····	·			
APPLICATION NO.	Fi	LING DATE	FIRST NAMED INVENTOR	ATTORNEY DOCKET NO.	CONFIRMATION NO.
09/588,478	(06/07/2000	Yasuhiro Morii	50073-030	8907
20277	7590	04/09/2004		EXAM	INER
MCDERM 600 13TH S		LL & EMERY		RUDE, Til	мотну L
	,	20005-3096	ART UNIT	PAPER NUMBER

γ				
		Application No.	Applicant(s)				
		09/588,478	MORII, YASUHIRO				
	Office Action Summary	Examiner	Art Unit				
		Timothy L Rude	2871				
The MAILING DATE of this communication appears on the cover sheet with the correspondence address Period for Reply							
THE - Exte after - if the - if NC - Failu Any	ORTENED STATUTORY PERIOD FOR REPLICATION OF THIS COMMUNICATION OF	.136(a). In no event, however, may a reply be timely within the statutory minimum of thirty (30) days will expire SIX (6) MONTHS from the cause the application to become ABANDONE	nely filed s will be considered timely. the mailing date of this communication. D (35 U.S.C. § 133).				
Status

DETAILED ACTION

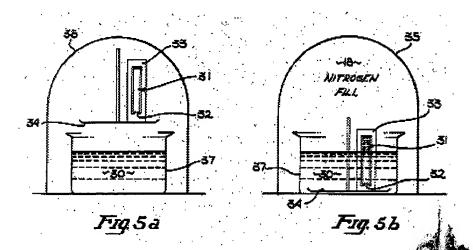
Yih teaches in Figures 1-6 the steps of adhesive application, evacuation, filling, sealing, etc. (Figures 1-5b, and col. 2, line 41 through col. 4 line 52) comprising forming a sealant between the two substrates (col. 3, lines 20-35) and around the outer peripheries of the substrates in such a manner that it partly reaches the edges of the substrates to form an opening (col. 3, lines 23-28) through which liquid crystal is to be injected into the space between the sealed substrates, and a step of setting the panel in a liquid crystal-injecting unit (col. 4, lines 10-17) having therein a container filled with liquid crystal, evacuating both the liquid crystal-injecting unit and the panel, putting the opening of the panel into the liquid crystal in the container (col. 5, lines 26-31), thereafter restoring the liquid crystal-injecting unit to have an atmospheric pressure (col. 4, lines 13-19 and col. 5, line 32 through col. 6, line 5) in that condition so that the liquid crystal is injected into the panel through its opening owing to the inner pressure difference between the unit and the panel (col. 4, lines 15-17), and finally sealing the opening of the panel in such a condition that the panel receives no external pressure (col. 4, line 19) to complete LCD assembly without bubble formation.

FIG. 2B

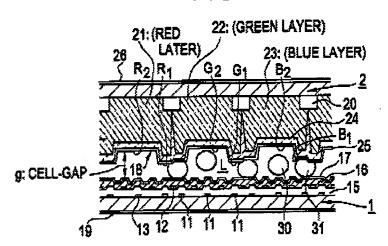
Suzuki teaches in Figures 2A and 2B defining a gap between the first and second substrate by disposing a spacer, 31, which is smaller than said gap, on a projecting pattern where spacers, 30, remain uncompressed so the liquid crystal molecules will not be subject to anomalous orientation and light leakage will be avoided (Abstract).

Suzuki is evidence that ordinary workers in the art of liquid crystals would find the reason, suggestion, or motivation to define a gap between the first and second substrate by disposing a spacer which is smaller than said gap, on a projecting pattern where spacers in the pixel regions remain uncompressed so the liquid crystal molecules will not be subject to anomalous orientation and light leakage will be avoided.

FIG.2

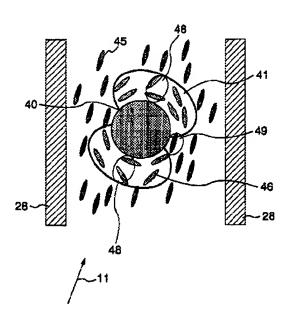
Utsumi teaches in Figures 1, 2, and 9, the use of long-chain alkyl group coated spacers (col. 10, lines 8-11) to improve contrast and viewing angle (col. 5, lines 36-40, col. 9 and Abstract).

Utsumi is evidence that ordinary workers in the art of liquid crystals would find the reason, suggestion, or motivation to add the use of long-chain alkyl group coated spacers to improve contrast and viewing angle.
